HISTORIC AND DESIGN REVIEW COMMISSION

September 18, 2019

HDRC CASE NO: 2019-117
ADDRESS: 434 SHERMAN ST
LEGAL DESCRIPTION: NCB 514 BLK 18 LOT E 75 FT OF 13
ZONING: R-6, H
CITY COUNCIL DIST.: 2
DISTRICT: Dignowity Hill Historic District
APPLICANT: Alvin Peters
OWNER: Waseem Ali Stephanie Zarriello
TYPE OF WORK: Construction of a 2-story, single-family residential structure
APPLICATION RECEIVED: February 27, 2019
60-DAY REVIEW: April 28, 2019 (Referred to DRC and postponed by applicant)
CASE MANAGER: Edward Hall

The applicant is requesting conceptual approval to construct a two story, single family residential structure on the lot at 434 Sherman Street, located at the corner of Sherman and N Olive, within the Dignowity Hill Historic District.

02 OLIVE STREET FENCE ELEVATION
SCALE: 1/4" = 1'- 0"

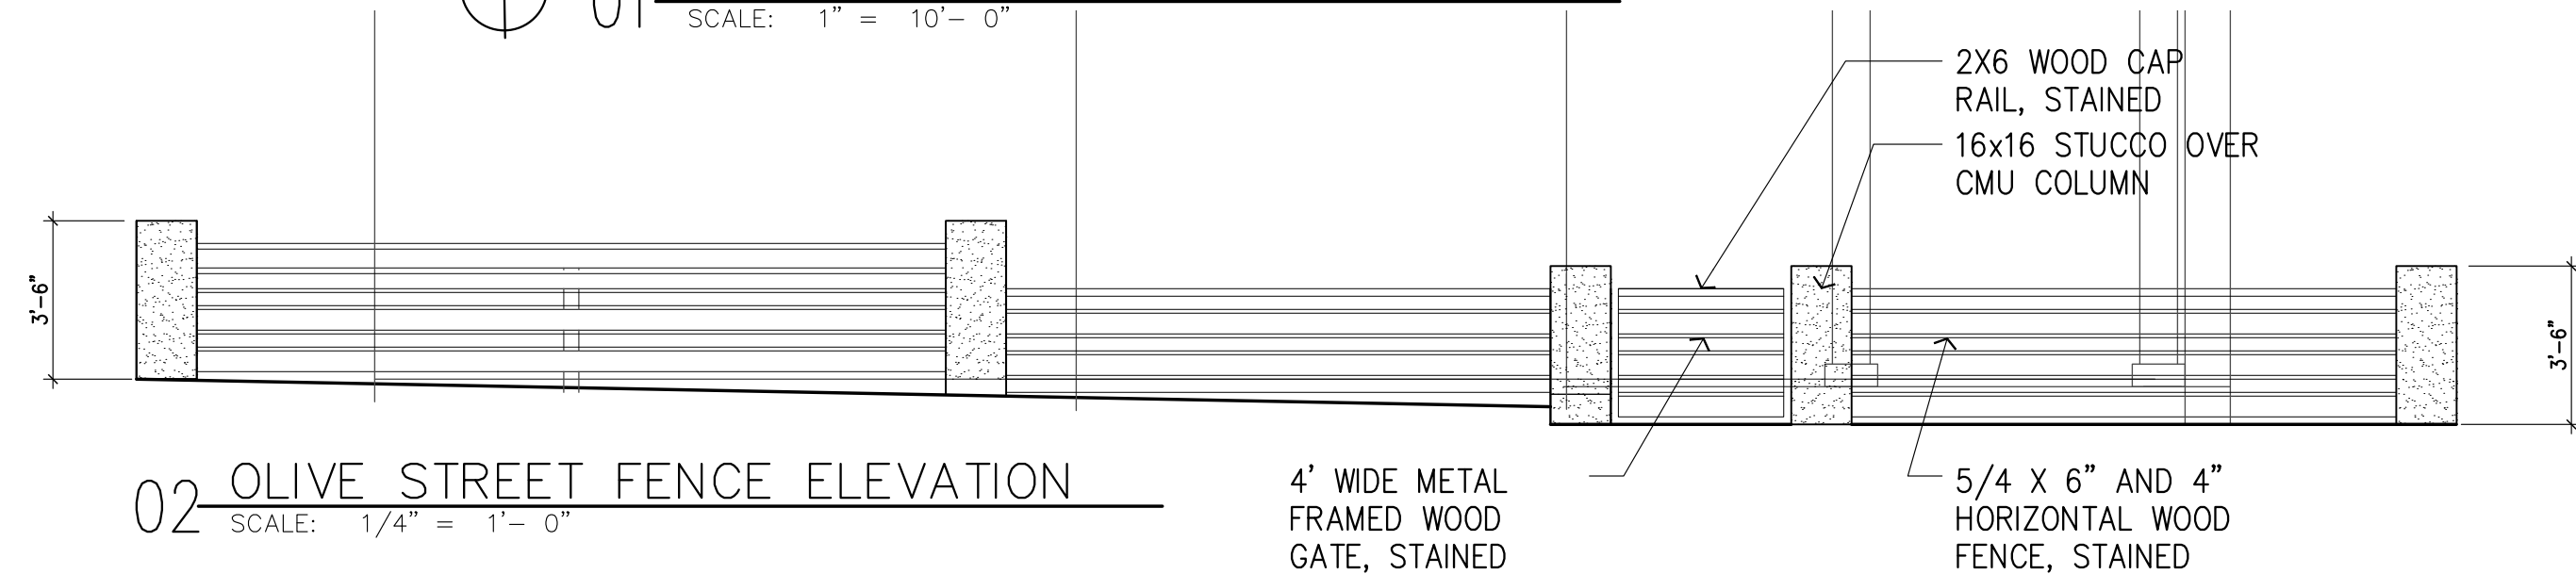
- y. FENCING – The applicant has proposed fencing that includes masonry columns and horizontal pickets. This is inconsistent with the historic fencing examples found historically in the district.

A1.1

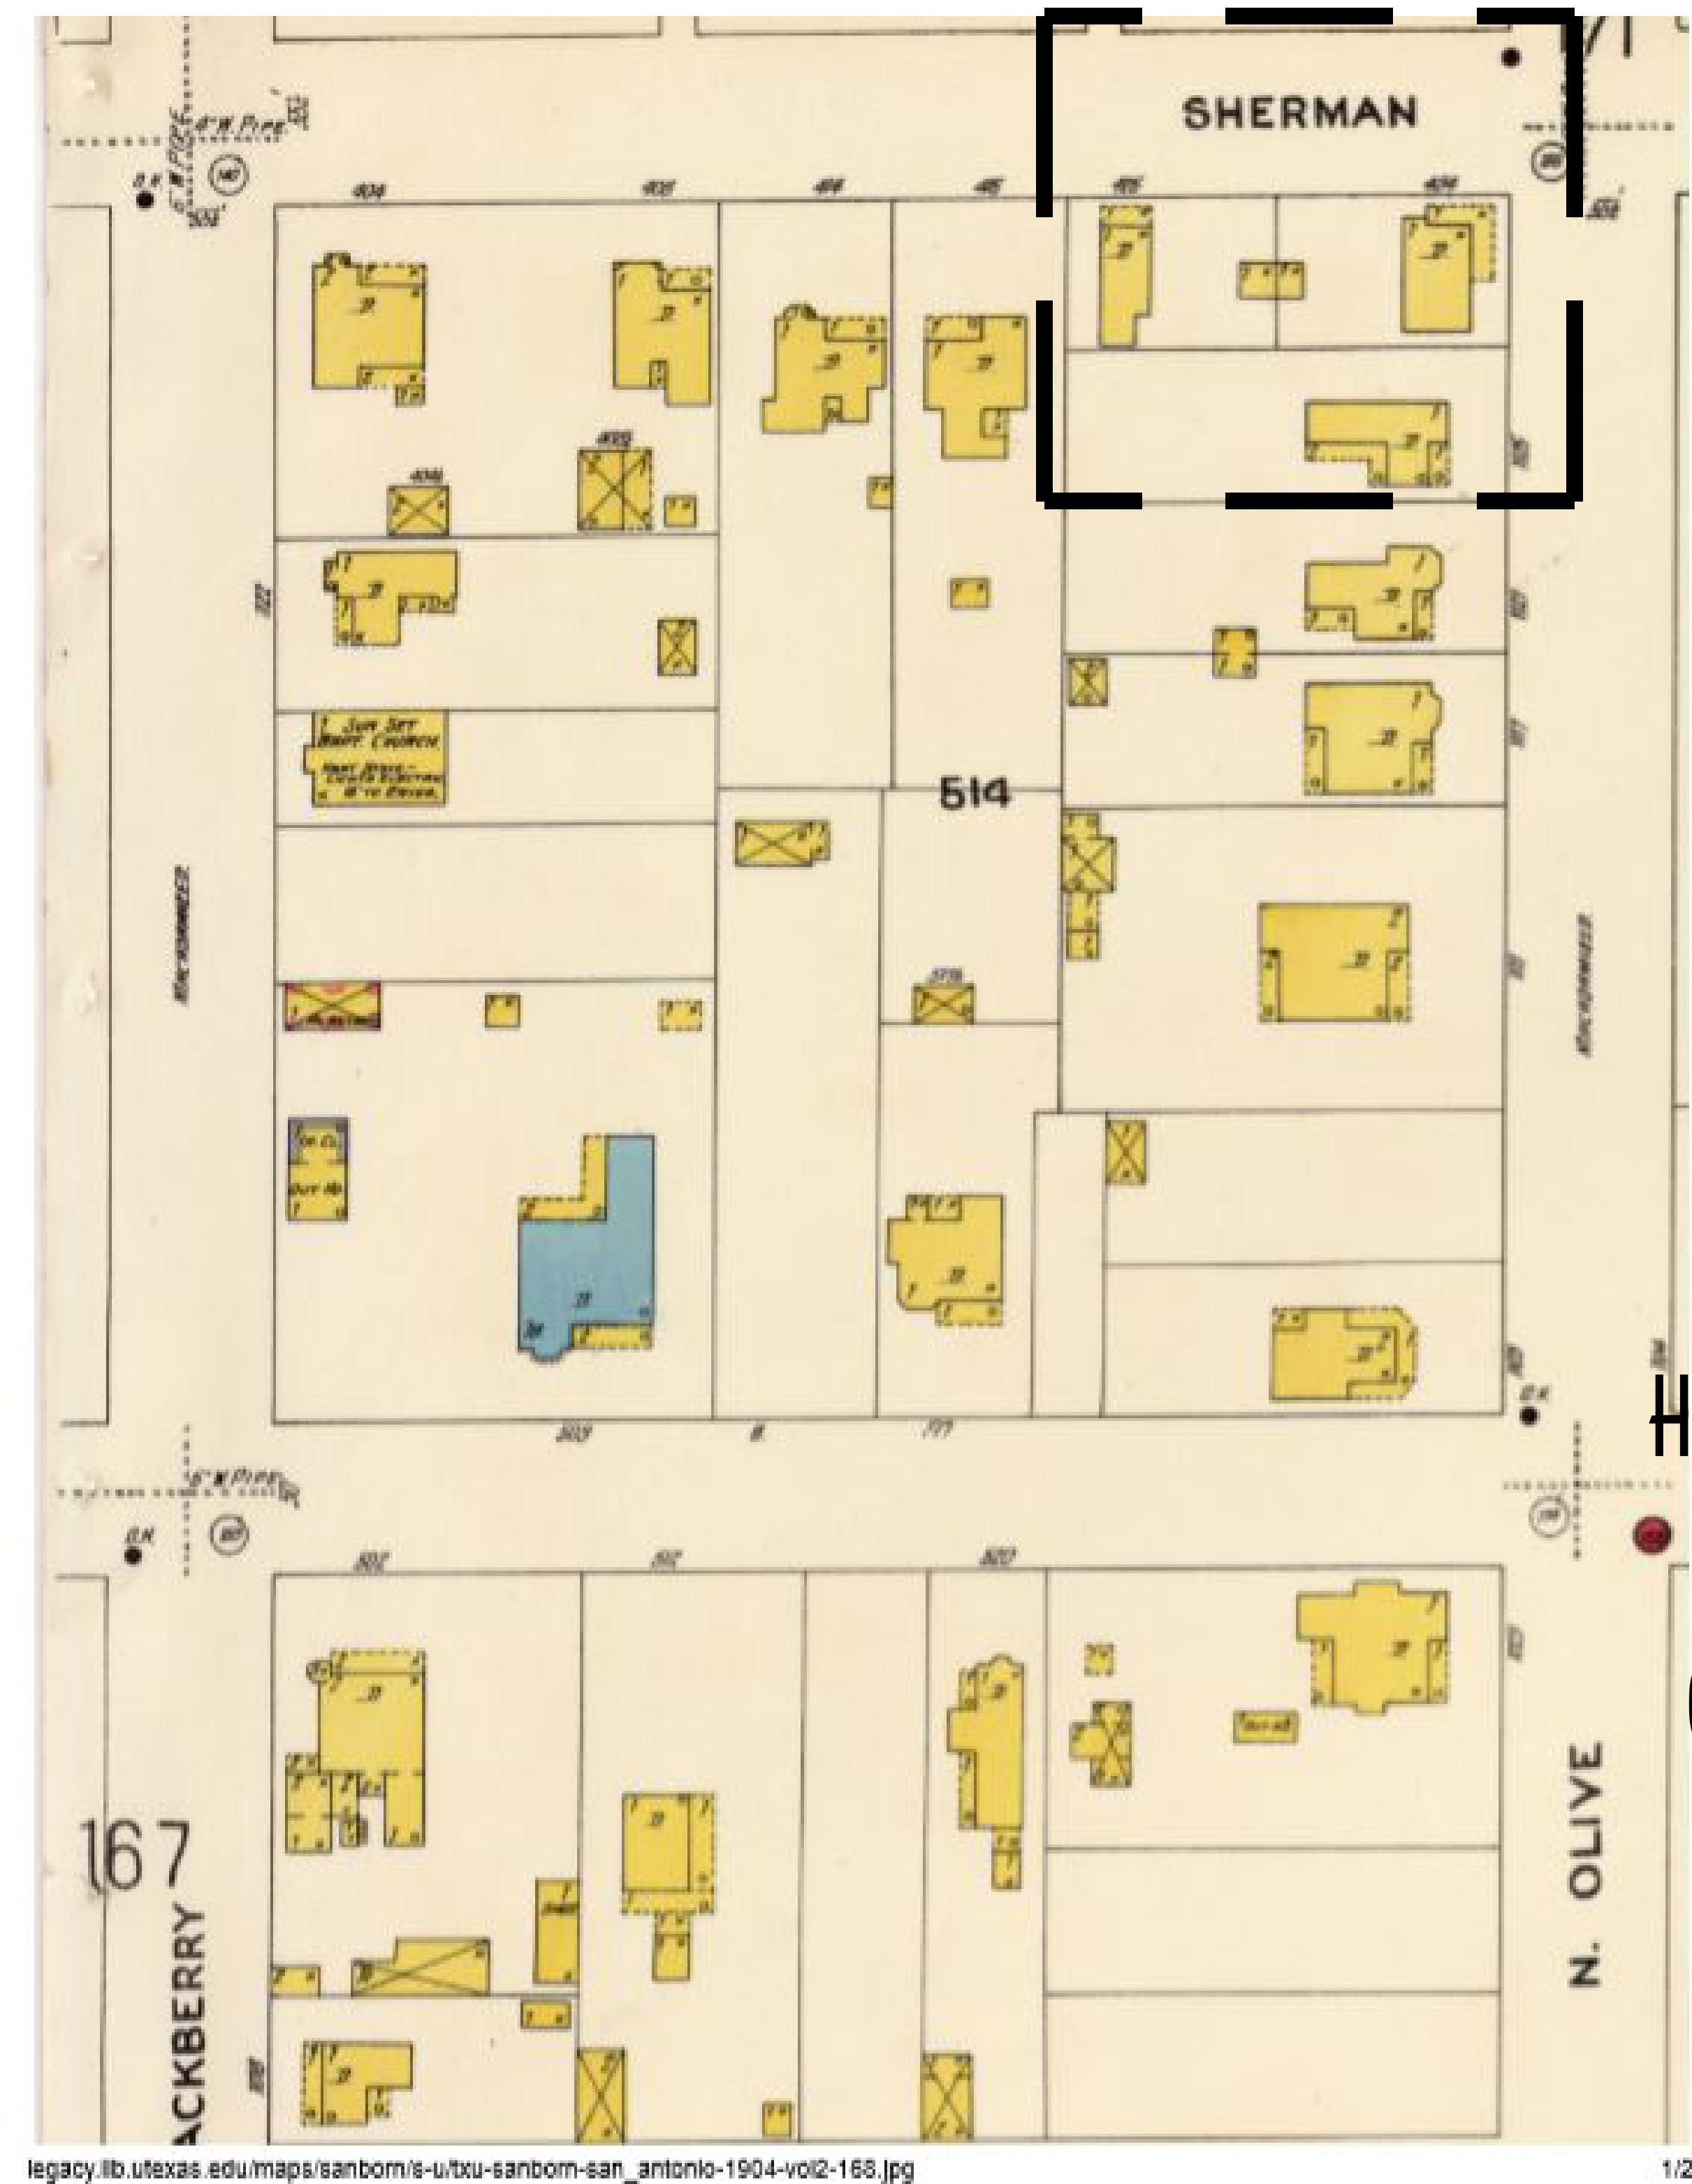
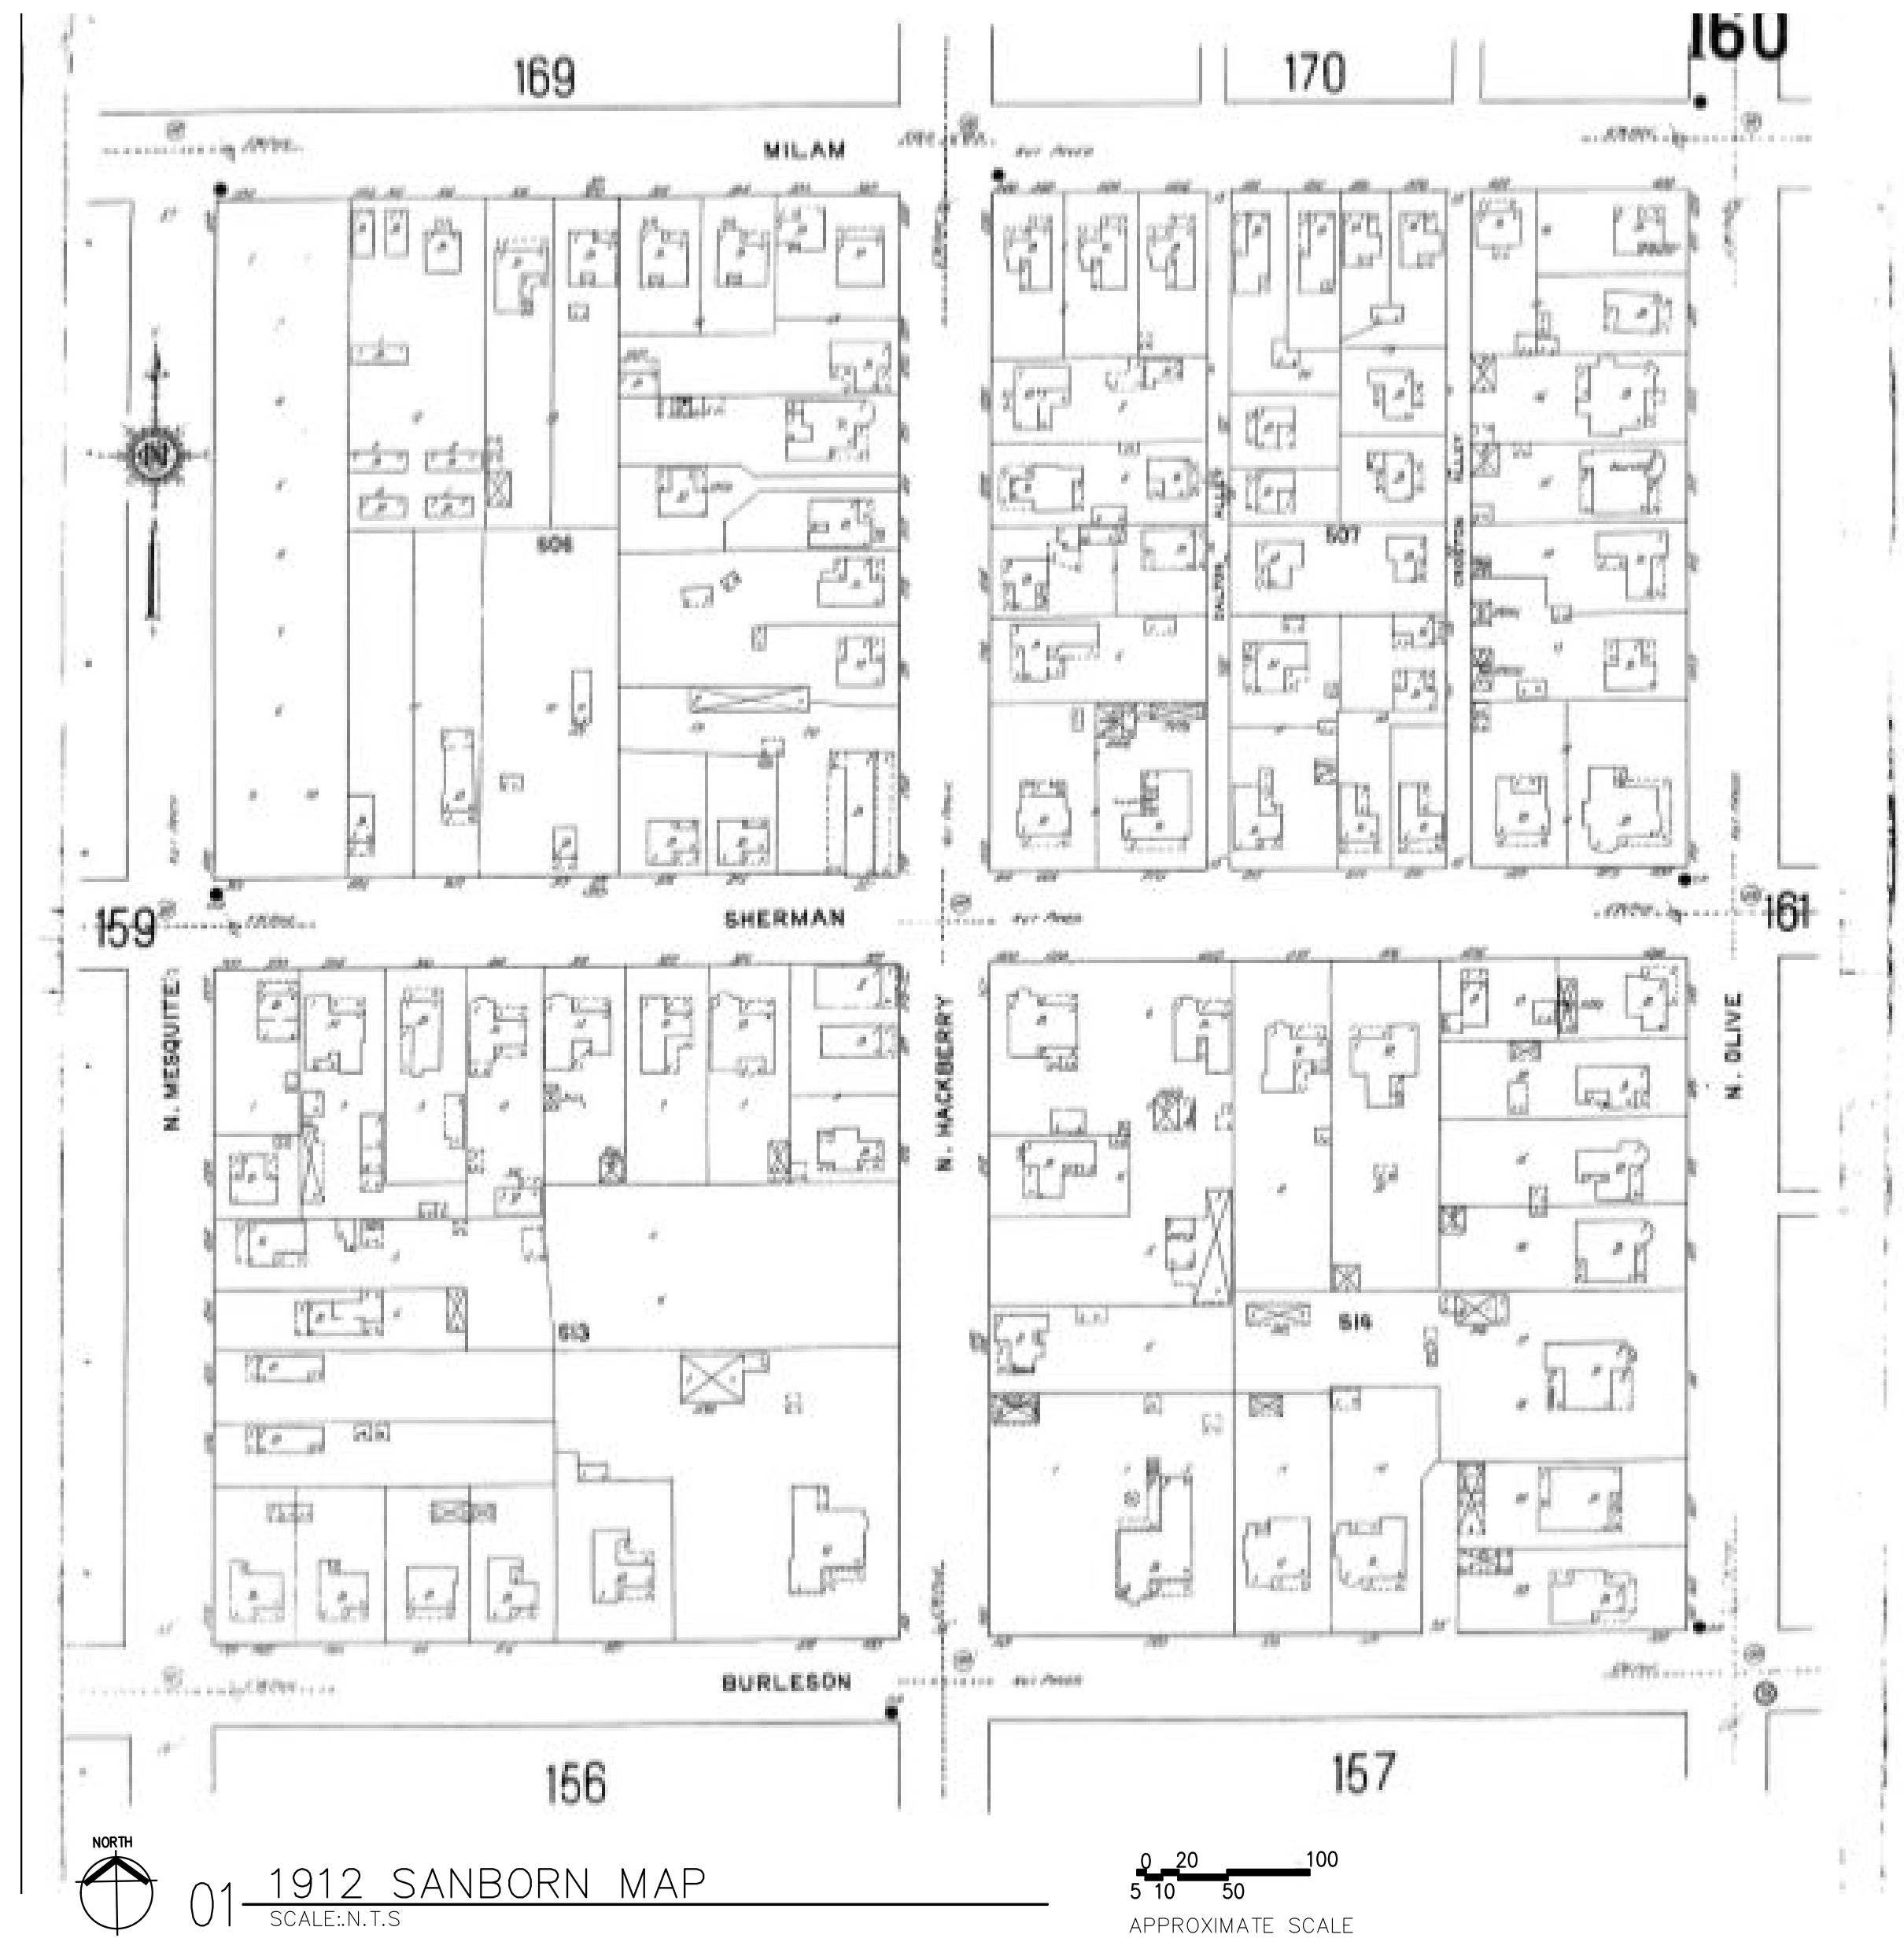
- j. **SETBACKS & ORIENTATION** – Per the site plan, the proposed rear setbacks are not consistent with zoning

- f. *We Concur. This Revised Plan with the detached Garage is now in compliance with zoning rear setbacks for rear building setback. We will seek a variance if required for the detached garage. Refer to Sheet A1.1.*
- g. *We Concur, the Building entrance is Oriented on N. Olive street.*
- h. *We Concur, We have reduced the Building foot print to 48.1% of the Lot size and have detached the Garage from the Main house to create two smaller masses. Our building does not exceed the adjacent structures by more than one story and our ground level is 16' below the ground level at the southern corner of Olive and Burleson.*
- i. *We Concur, the First Floor height of adjacent residences are 1'-4' above finish grade. Our Proposed First Floor Height will be approximate 1'-2' above finish grade. This will comply with the Design Guidelines.*
